APPLICATION NO.	FILING DATE	FIRST NAMED INVENTOR	ATTORNEY DOCKET NO.	CONFIRMATION NO.
10/583,230	06/16/2006	Fabien Frederic Jousse	T7106(C)	8226

Application Number: 10/583,230
Filing Date: June 16, 2006
Appellant(s): JOUSSE, FABIEN FREDERIC

EXAMINER'S ANSWER

Fig. 2a

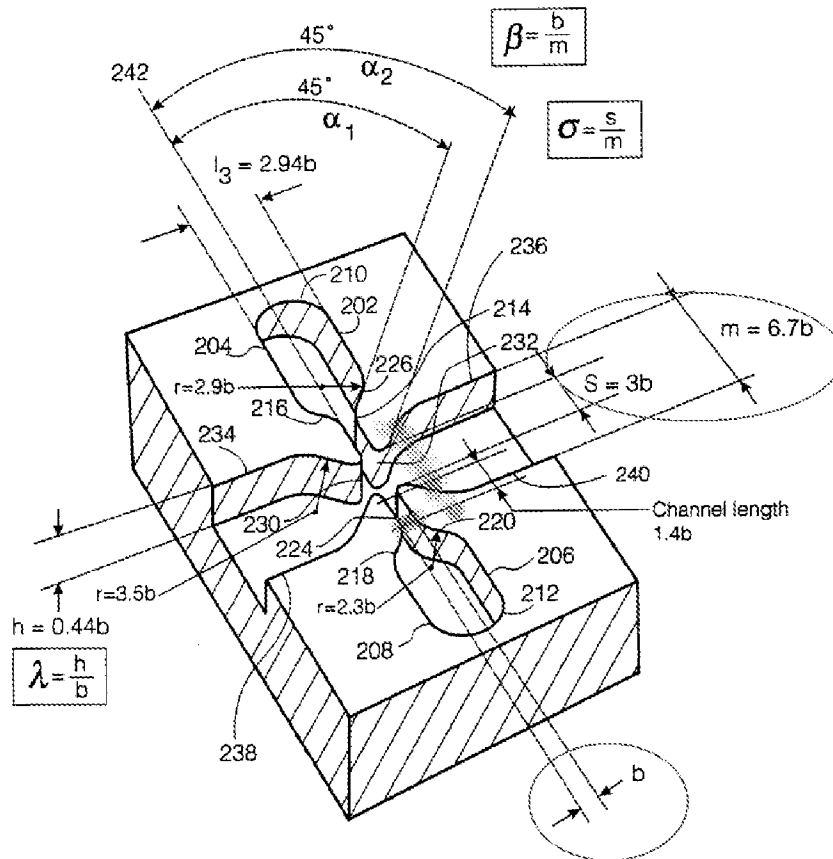
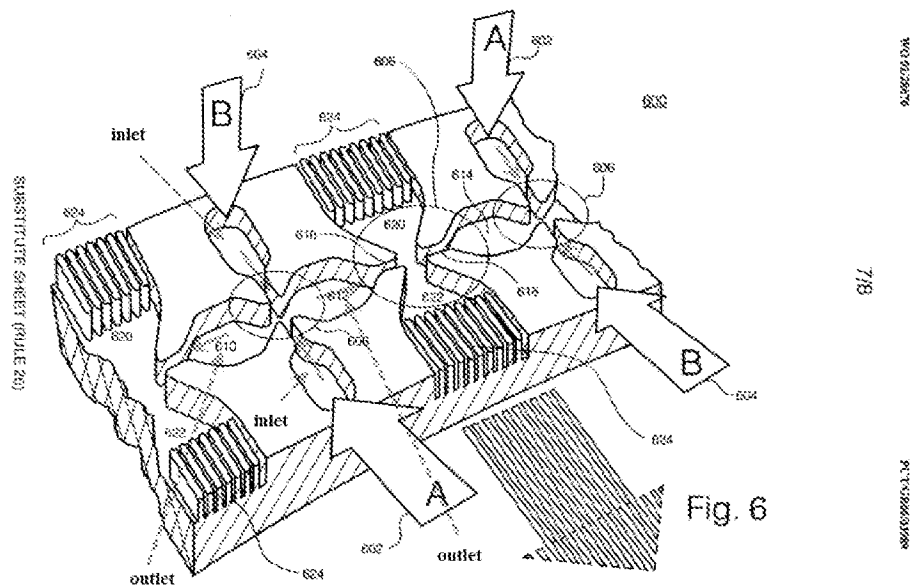
- first and second fluid supply sources (e.g., first fluid and second fluid, respectively, P13/L19-20 & Fig. 6 (602, 604)),
- the first and second supply sources supplying microfluidic reactors arranged in parallel (e.g., mixers, P13/L22-23 & Fig. 6 (606)) via an upstream channel or channels (see annotated arrows indicating flow pattern in Fig. 6 below), said upstream channel or channels positioned before the microfluidics reactors,
- the reactors each having at least one downstream channel which is positioned after the reactors (see annotation in Fig. 6 below); and
- the microfluidic reactors are all identical (see identical reactors 606 as shown in Fig. 6).

Regarding the resistance of its upstream channel at least 10, 100 times larger than the downstream channel, it is noted that the channel width b (upstream channels) is smaller than the exit channel width m or s (downstream channels), see Fig. 2a below. Therefore, while mixing fluids having same characteristics and the surface of each channels and reactors are made of same material with same surface smoothness and dimensions, it will display the flow resistance of all the upstream channels of the reactors is higher than the flow resistance in the down stream channels.

With respect to arguments regarding Allen et al. fail to teach resistance, Fig. 6 has been annotated to note Examiner's view of inlets & outlets. Although the reference is silent on resistance, the specification details on the dimensions of the device. See annotation in Fig. 2a showing the inlet width " b " is narrower than the outlet width i.e., " $3b$ ", " $6.7b$ ", which would reads on the inlet having higher resistance than the outlet, assuming all other variables are constant.
